2.0

PROPOSED SCHEME CHANGES

2.3 FIRST FLOOR PLAN

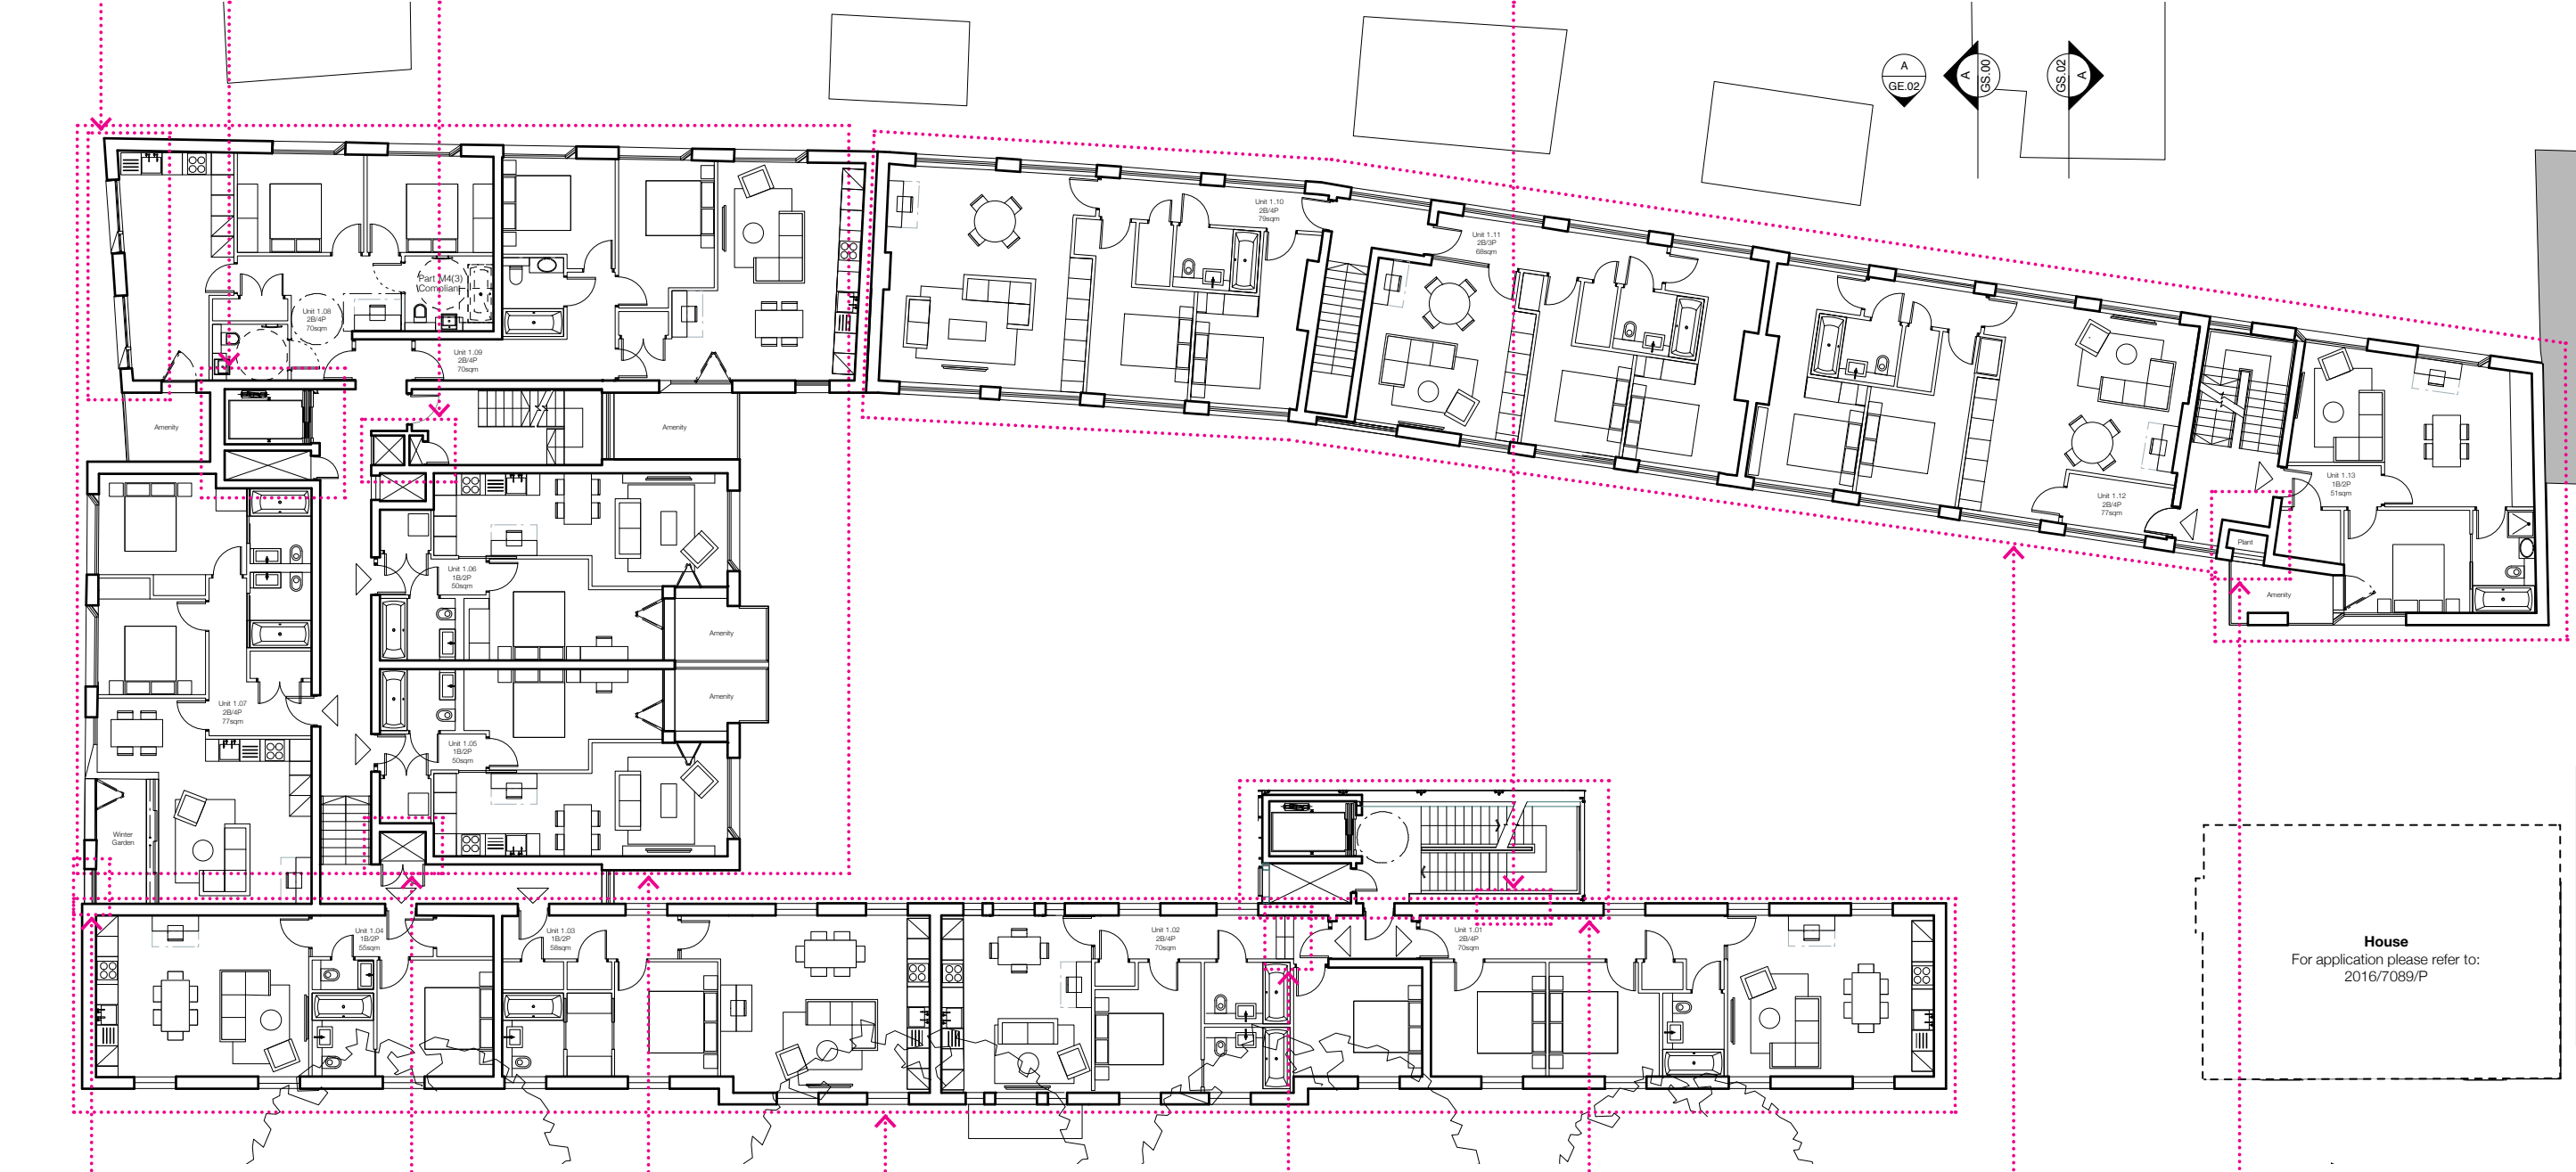
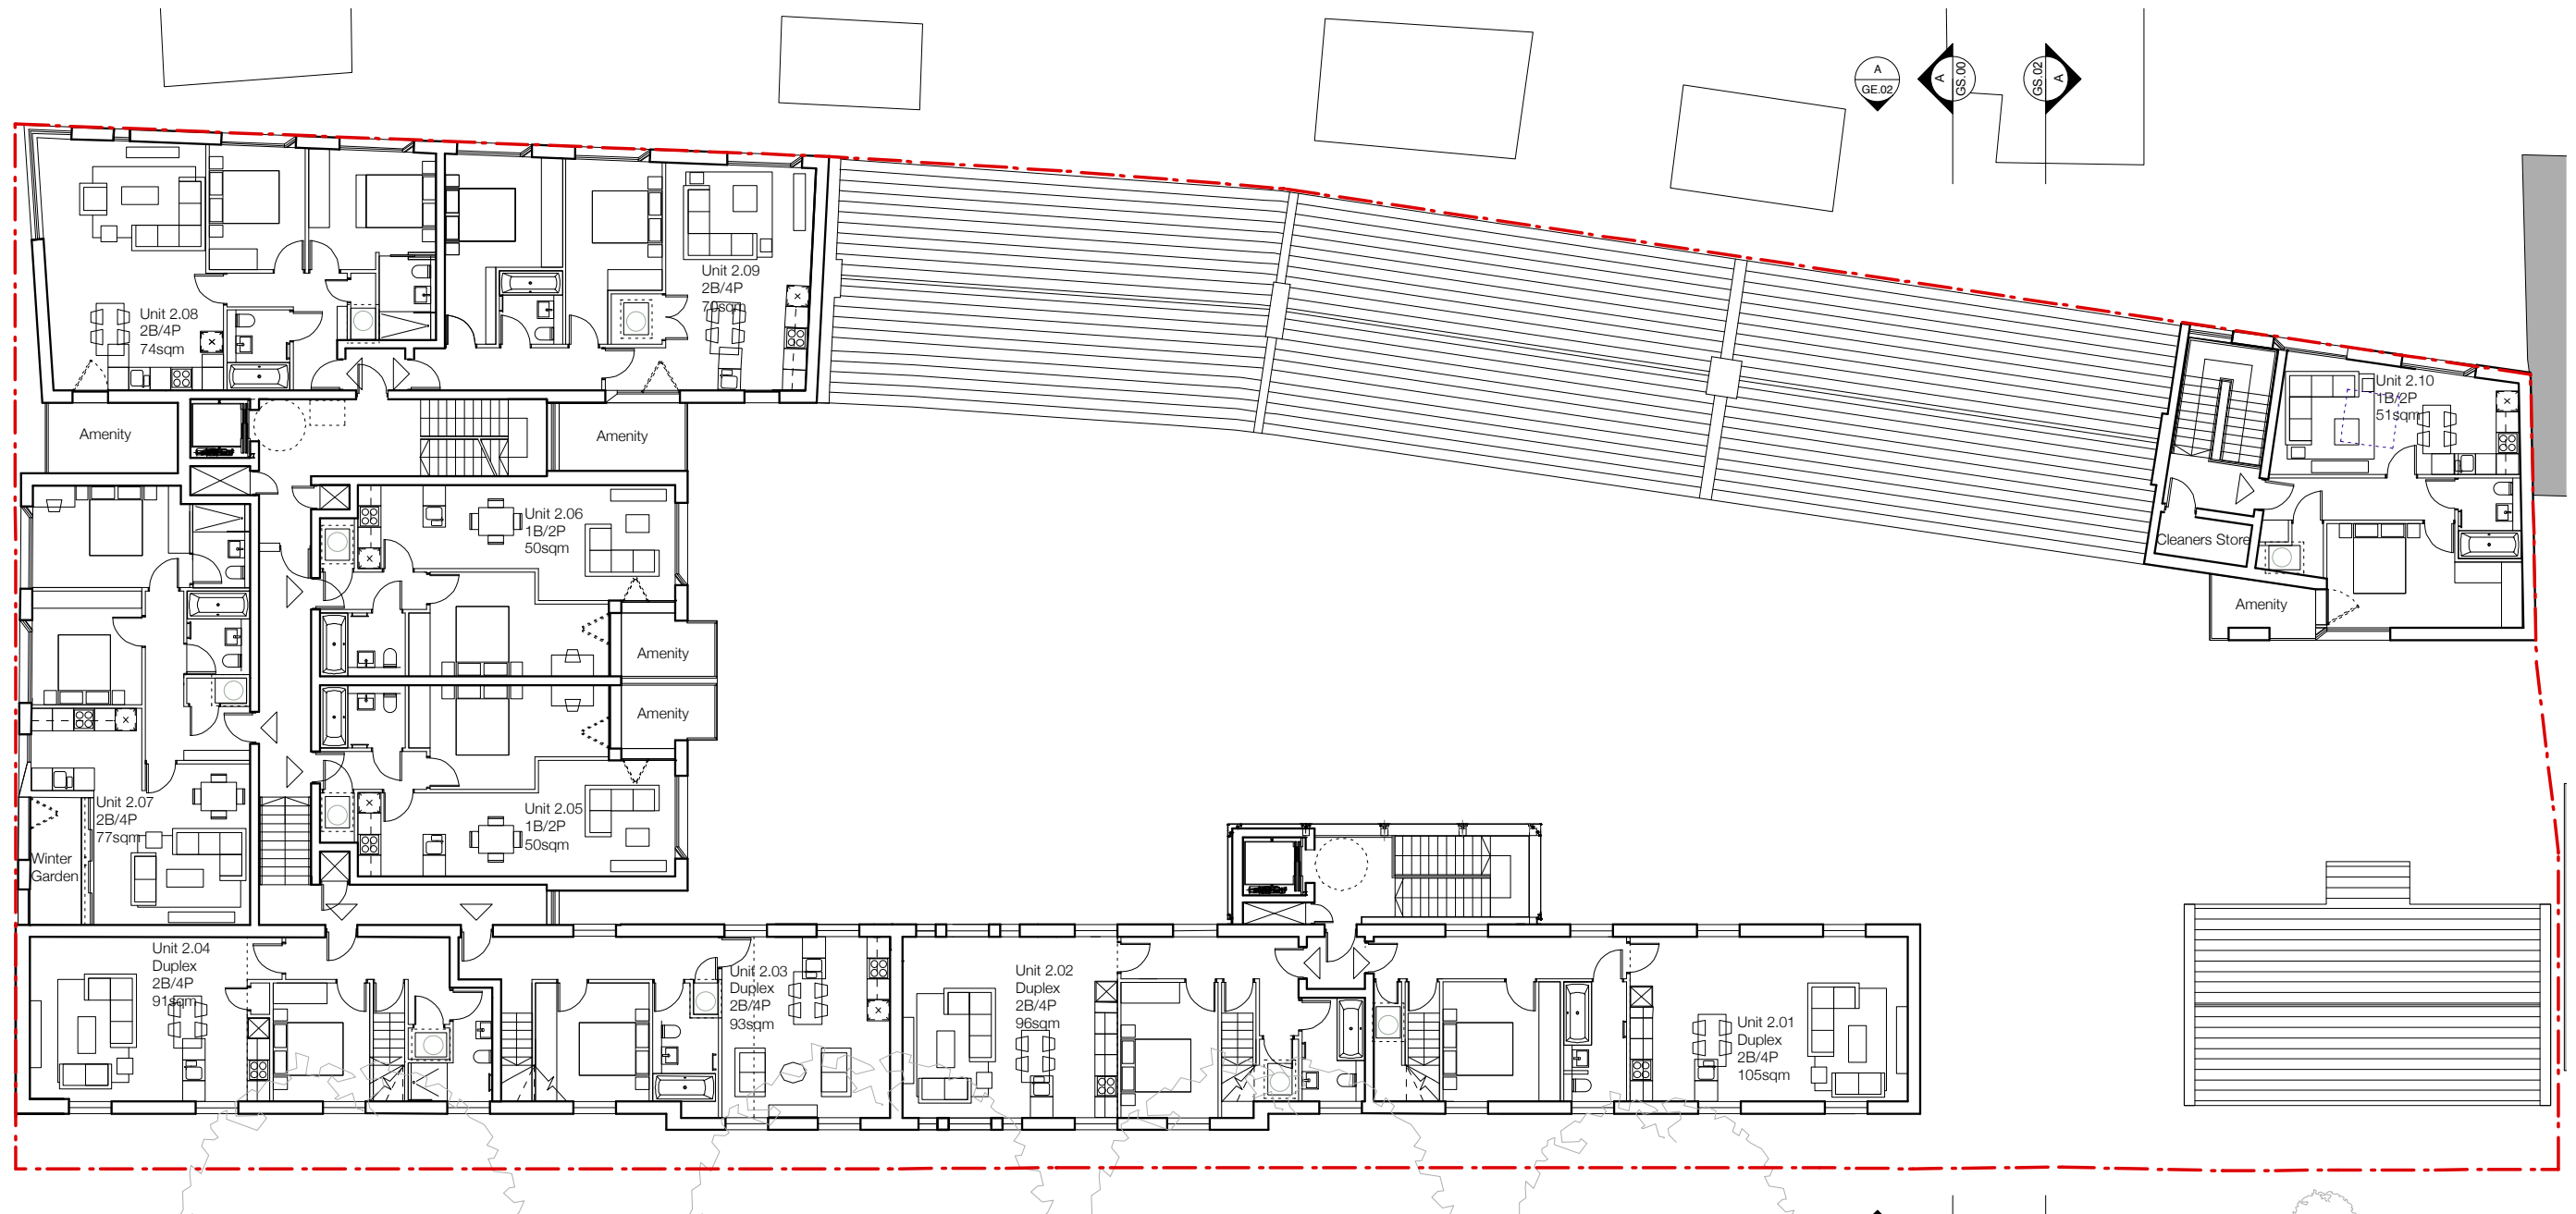
Building Facade Angle
Adjusted for Buildability whilst
Retaining the Architectural
Language.

Risers Enlarged as per Plant
Requirements

Risers Added as per
Plant Requirements

Window Infilled to
Achieve Fire Rating

Glass Balustrade Added
for Guarding.

Riser Increased
as per M&E Requirements

Block B Interior
Layouts Adjusted for
Marketing Purposes.

Block A Interior
Layouts Adjusted for
Marketing Purposes.

Stair Added to Accommodate
Existing Internal Level Change

Riser Enlarged as per M&E
Requirements. Glass Box Size
Increased due to Structural
Requirements.

Block C/D Interior
Layouts Adjusted for
Marketing Purposes.

Plant Room Added
as per M&E Requirements
